**Nuclear Regulatory Commission's
Request for Additional Information
on the Draft
Waste Incidental to Reprocessing Evaluation
for Waste Management Area C
at the Hanford Site**

Chris McKenney, David Esh, and Hans Arlt

Division of Decommissioning, Uranium Recovery, and Waste Management (DUWP)
Office of Nuclear Material Safety and Safeguards (NMSS)
U.S. Nuclear Regulatory Commission (NRC)

Thursday, May 30, 6:00 – 8:00 p.m.
Richland, WA

Figure C-1 from the WMA-C PA

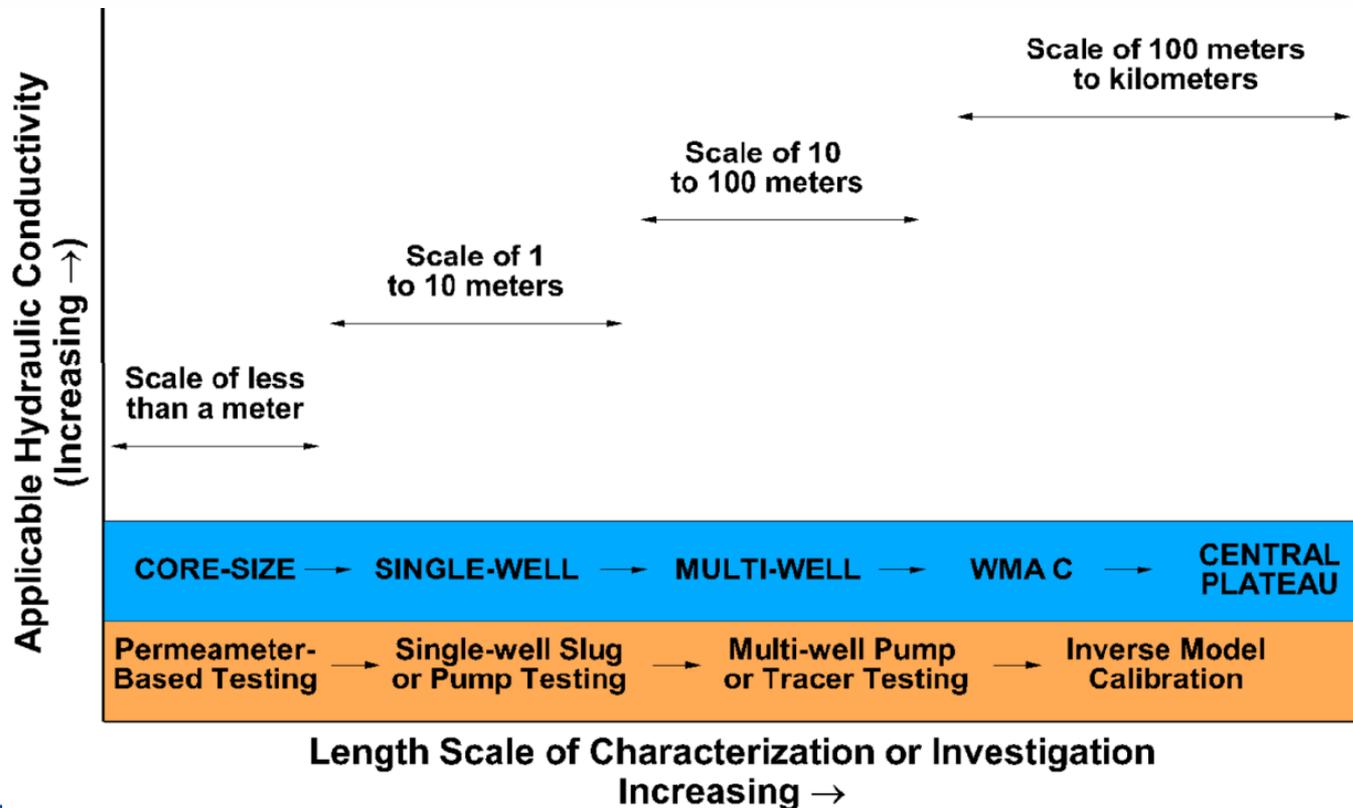
RAI 2-10 Comment: Additional information is needed to support a technical basis for using a relatively high hydraulic conductivity value for the unconfined aquifer.

- The WMA C PA document shows that the saturated zone Darcy flux is an important parameter.

Figure C-6 from the WMA-C PA

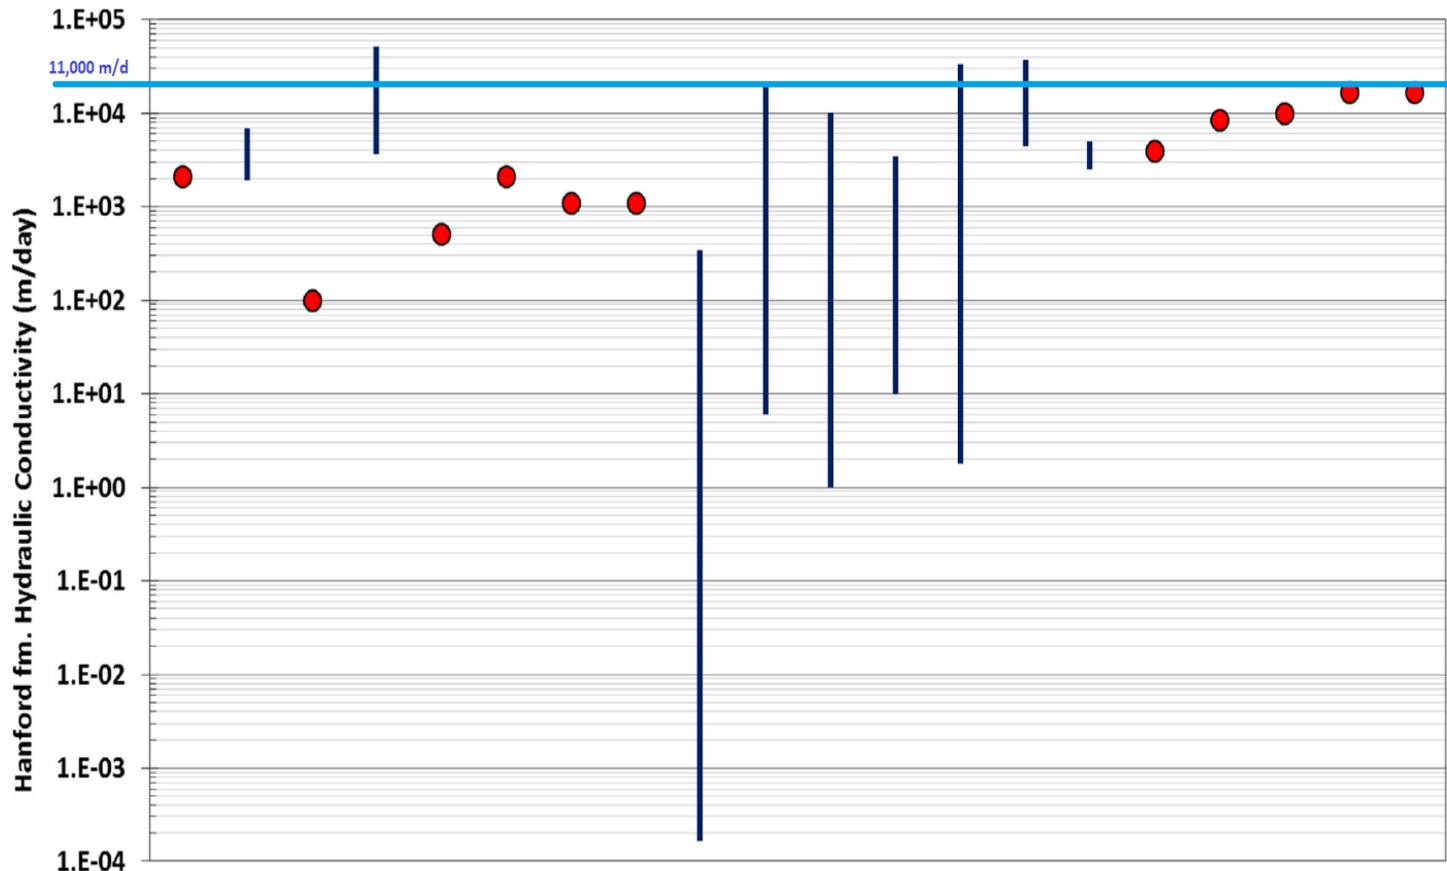
RAI 2-10 Comment continued

- Previous sources provided a lower range of hydraulic conductivity values compared to the current average WMA-C PA value of 11,000 m/d.

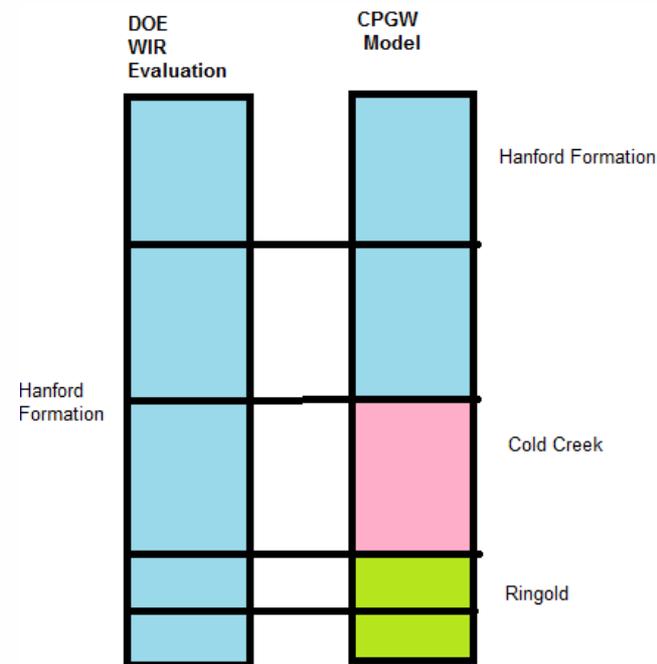
RAI 2-13 Comment: Differences in the conceptual hydrogeological models near WMA C between the regional Central Plateau Groundwater (CPGW) model and the WMA C STOMP model are considerable and some of the techniques for abstracting information and data from the CPGW model to the STOMP model require additional information.

- Differences in the hydrogeological units between the STOMP model in the WIR Evaluation and the CPGW model (see example figure).
